MAG 208 Water Quality Management Plan
Small Plant Review and Approval
for

The Preserve at Goldfield Ranch Water Reclamation Facility

May 28, 2008

Summary of Modifications in Response to FMYN Comments

WRF Conceptual Site Plan

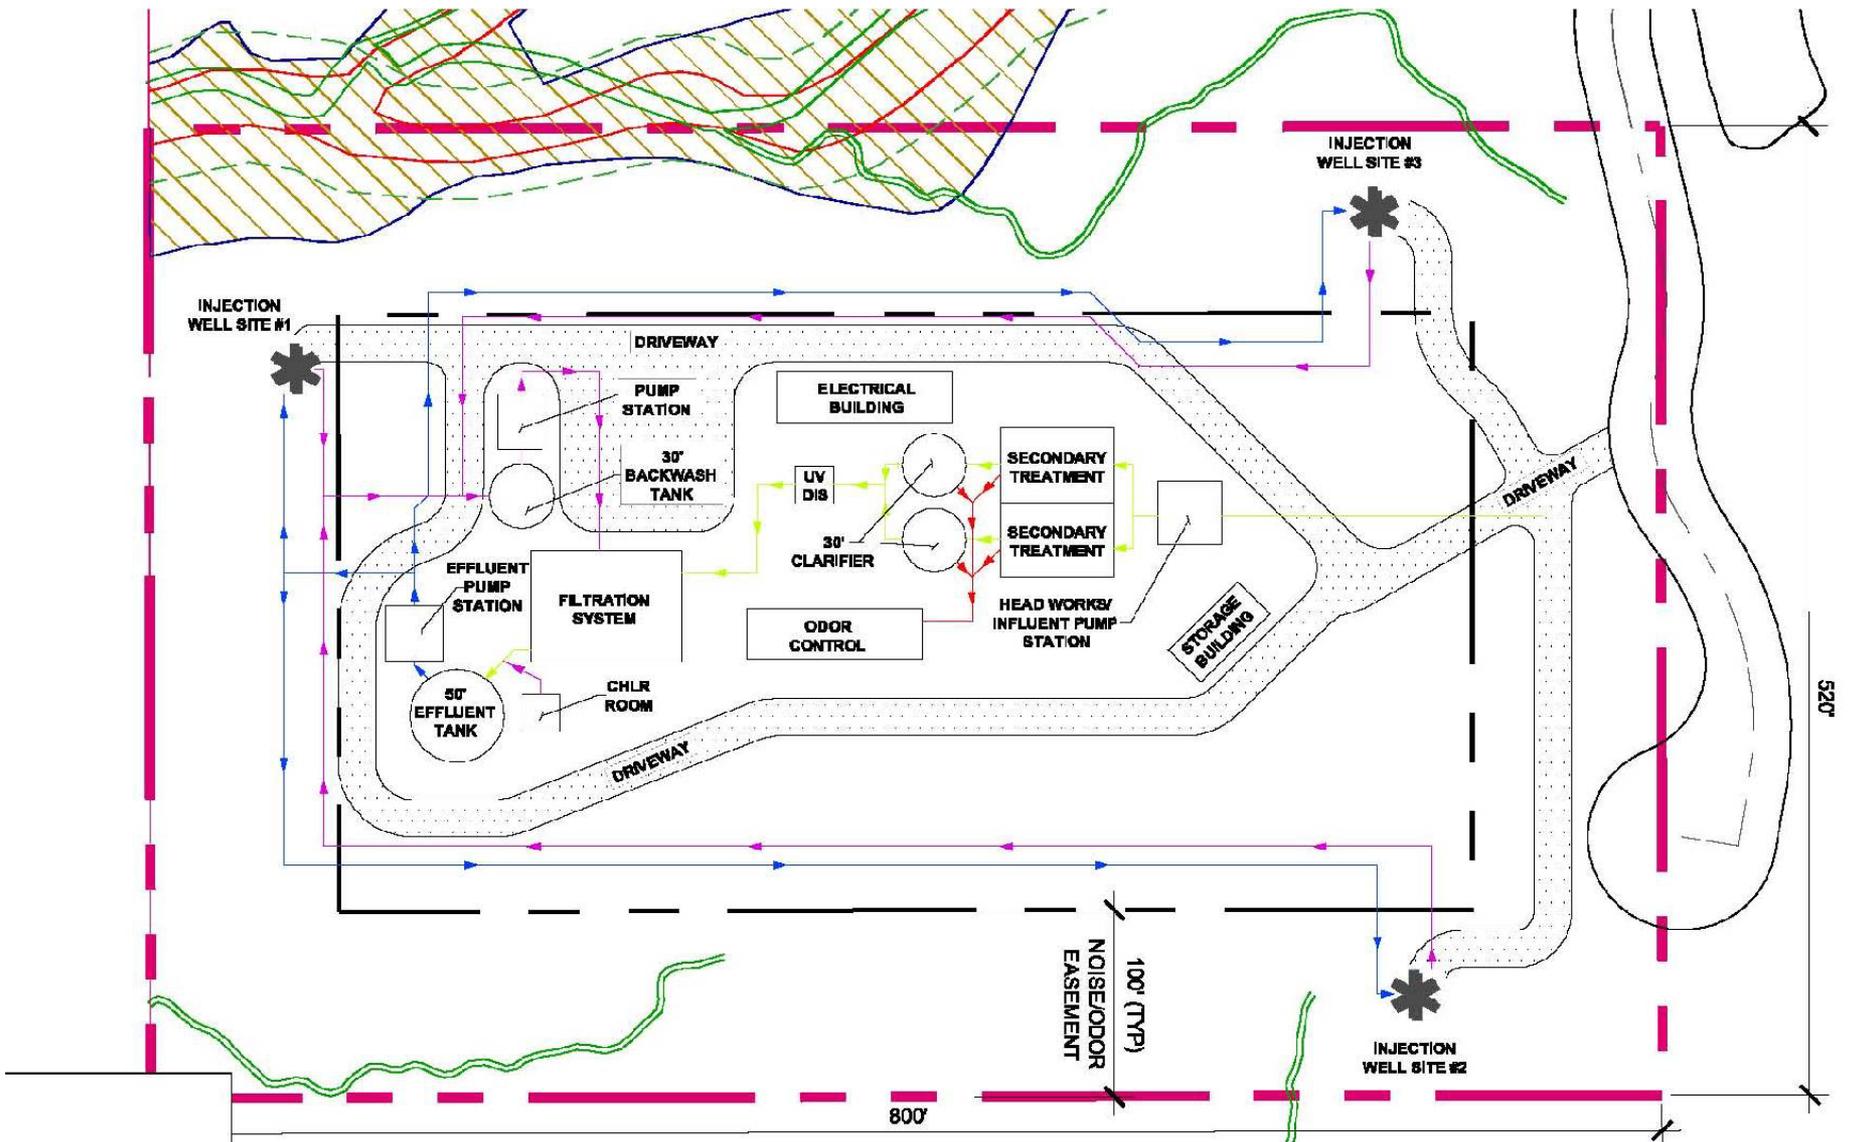
- Comment: Commit to specific treatment plan to identify noise, odor potential
- Response:
 - Conceptual site plan shows 100' setbacks
 - Nearest adjacent neighbors are within The Preserve development
 - Full noise, odor and aesthetic controls means:
 - Noise does not exceed 50 decibels at property boundary
 - Normal conversation = 60 decibels
 - All odor-producing components of the facility are fully enclosed (CLOSED SYSTEM)
 - Odor control devices are installed on all vents
 - Fencing aesthetically matched to surrounding area (AAC R18-9-B201)

- Comment: Provide detailed site plan
- Response:
 - Conceptual site plan provided
 - Engineered site plan to be provided at time of Aquifer Protection Permit and Underground Storage Facility permit applications

1.3.2. Service Area

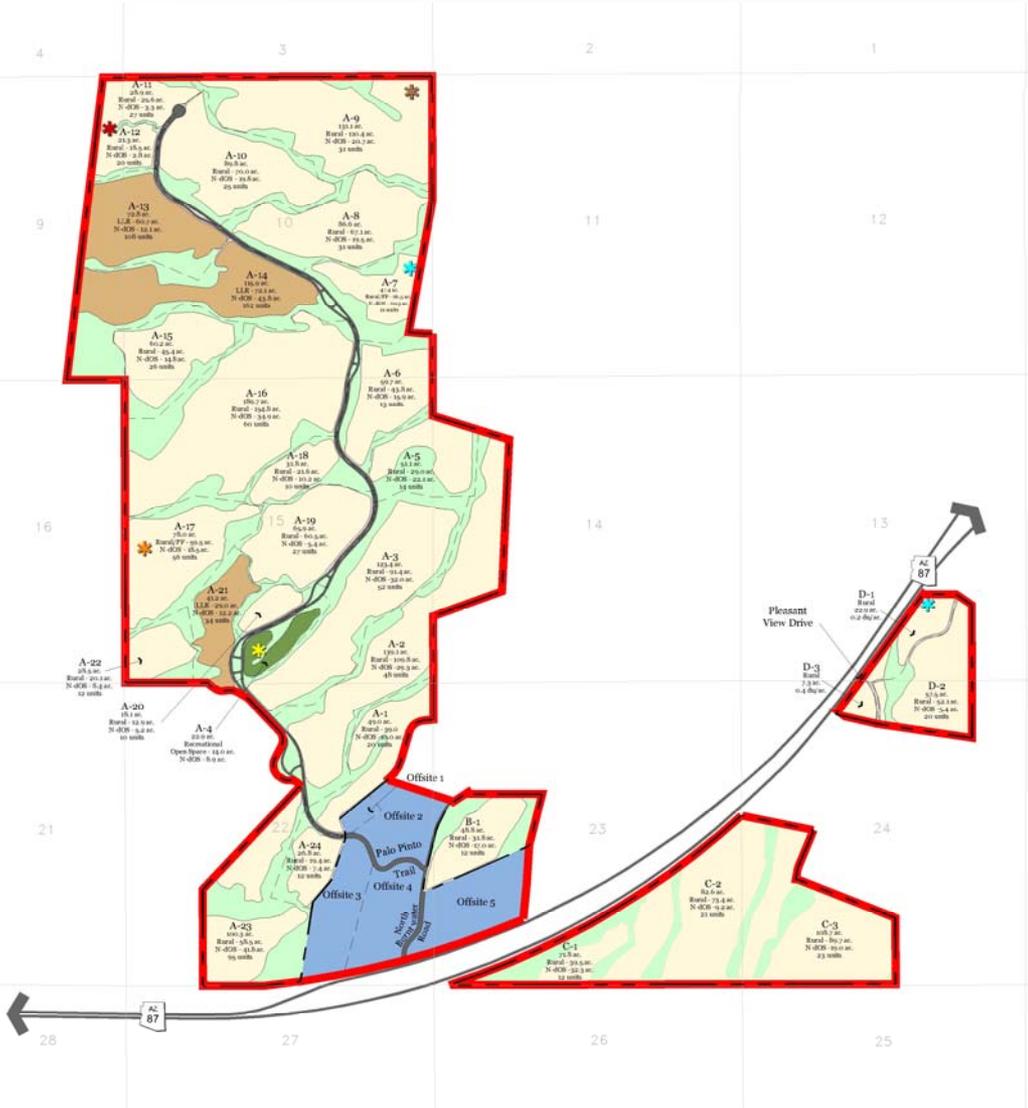
Issue: The SRP-MIC Report suggests the 208 Amendment Service Area may be eligible for expansion to serve the regional wastewater treatment needs of additional development within the entire area.

- The Service Area of the 208 Amendment will be expanded to include Parcels C and D.
- There is sufficient property both within and surrounding the plant site to accommodate an expansion.

Topographic Constraints

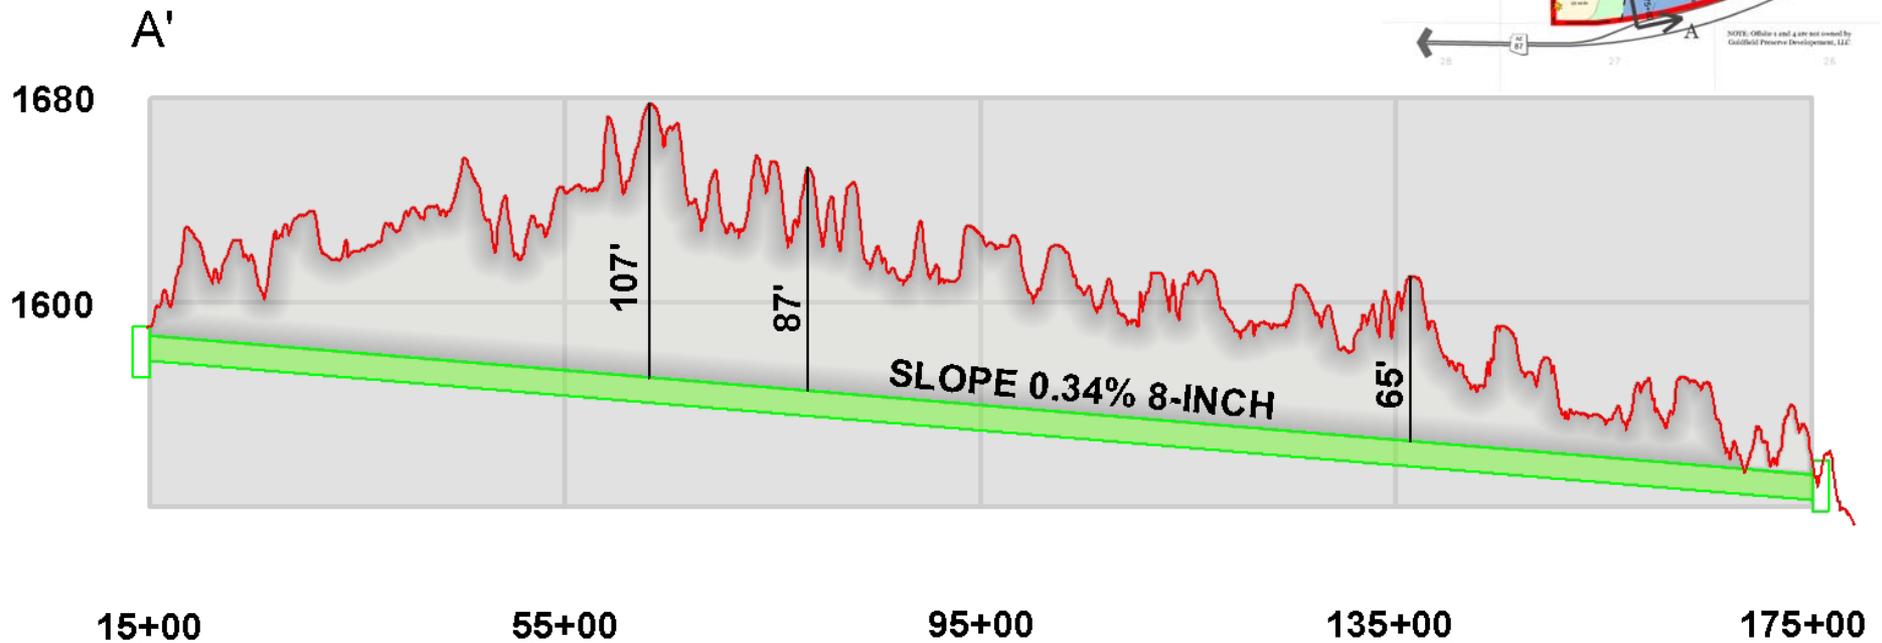
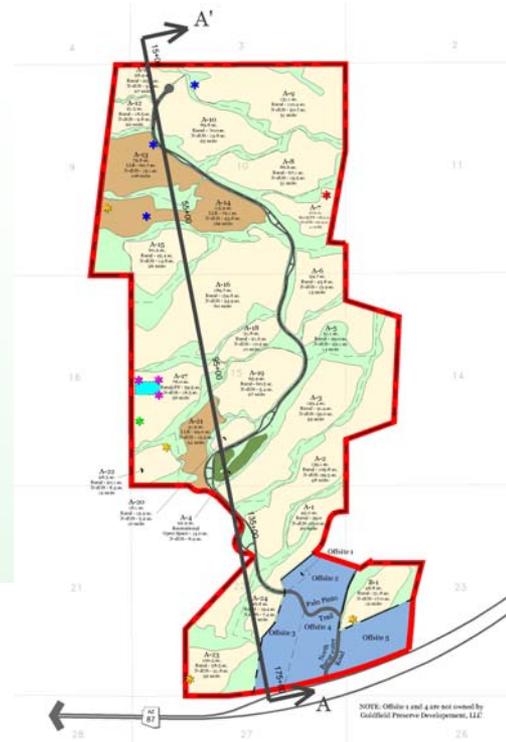
- Comment: Reduce need for septic
- Response:
 - Parcels C&D proposed for 1.5+ acre lots
 - Distance, topography, jurisdictional waters and State Route 87 constrain the feasibility of serving these parcels

- Topographic/hydrologic constraints
- Limited access to parcels does not coincide with natural fall of land
- Existing 5 acre or larger lots to east operate on septic systems
- Economically infeasible – separate property owners
